AMENDMENT NO. One (1)

BID NO. 1629

TITLE: Installation of New Carpet (Tiles) at Gallup Police Admin Bldg

DIAGRAM #1: ADMIN HALLWAY

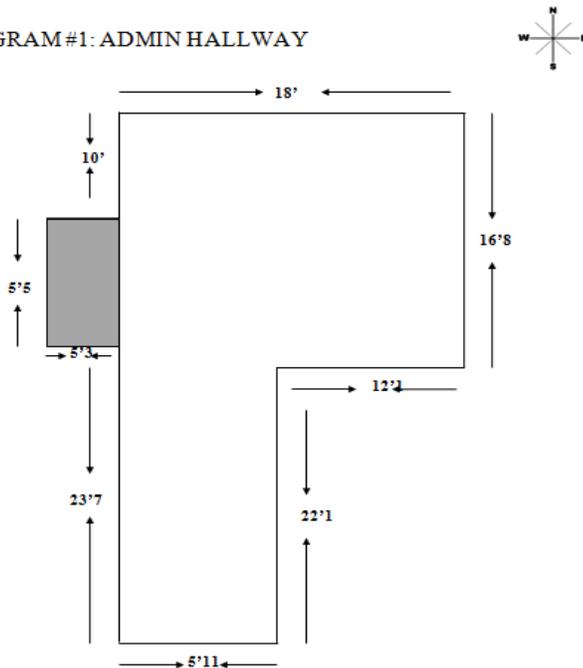
- 1.) Carpet face weight shall be revised to **18 oz. Nylon** (no pattern), please revise any indication in bid documents that refer to the 28 oz. carpet tile. Cove base remains the same.
- 2.) The spaces in diagrams #1, #2, #6, #8, #10, #11 currently have tile; spaces in diagrams #3, #4, #5, #9, #12, #13, #14, #15, #16#17 have carpet with threshold strips. Alternate space in diagrams #18 is cement floor and space in diagram #7 is a combination of cement/tile floor.
- 3.) On diagram #1, the inlet that is currently “gray” shall be figured into project. Space is 5’3 x 5’5.

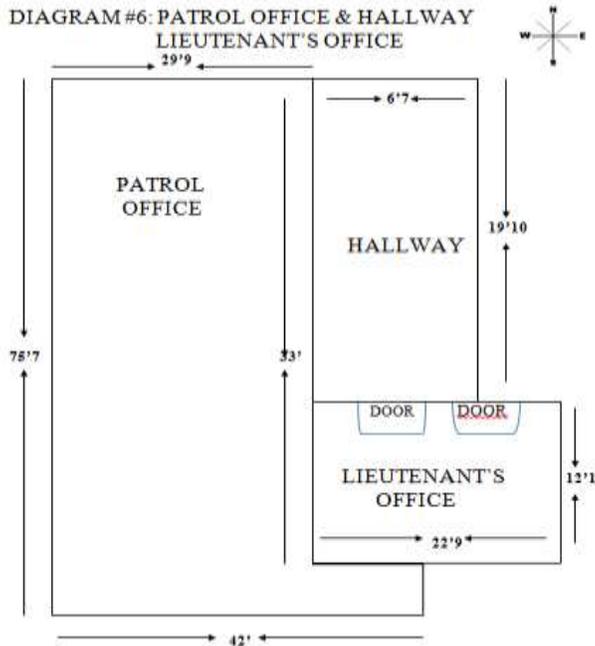
- 4.) On diagram #6, in the Lieutenant's Office, there are two doors that bottoms need to be cut down 2-3 inches for carpet installation purposes.

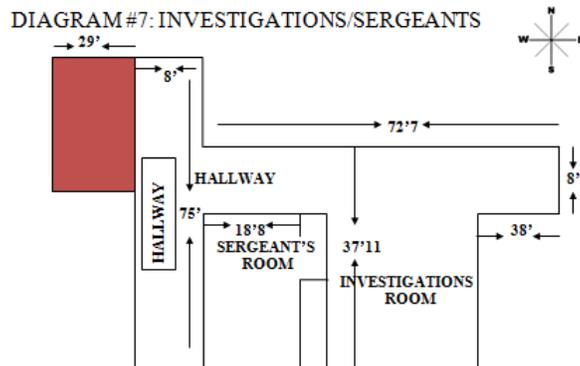
- 5.) On diagram #7, the Conference Room (red highlight) in the upper left hand corner has been eliminated from project. Please do not figure this space in your cost of project.

DIAGRAM #8: INVESTIGATIONS/SERGEANTS

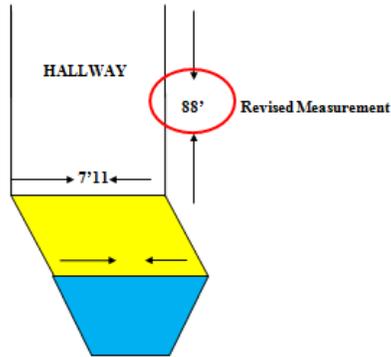
- 6.) On diagram #8, the end of hallway, shall be figured as a 9 x 10 space (yellow highlight) and a 4 x 9 space (teal highlight). Also the East side of the hallway's measurement shall be revised to 88' (not 8').

DIAGRAM #17: LT. MORRISSETTE ROOM

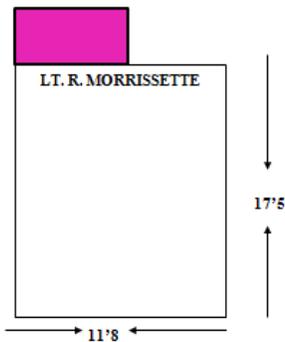
- 7.) On diagram #17, Lt. Morrissett’s Office has an additional inlet space on the North wall that measures 4’ x 6’ (pink highlight) and shall be figured into the cost for that particular space.
